ECE/TRANS/WP.29/2009/82
29 July 2009

Proposal for Supplement 19 to the 01 series of amendments to Regulation No. 6
(Direction indicators)

Submitted by the Working Party on Lighting and Light-Signalling */

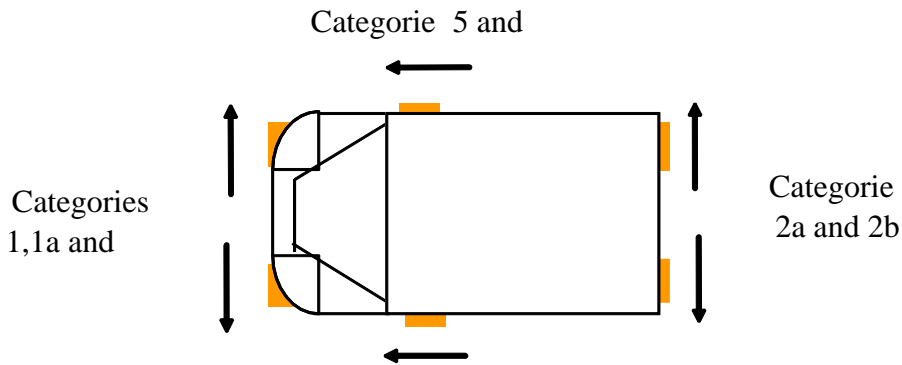
Annex 3, amend to read:

"....."

The direction in which the arrows on the approval mark point, according to the category of the device, is shown below:
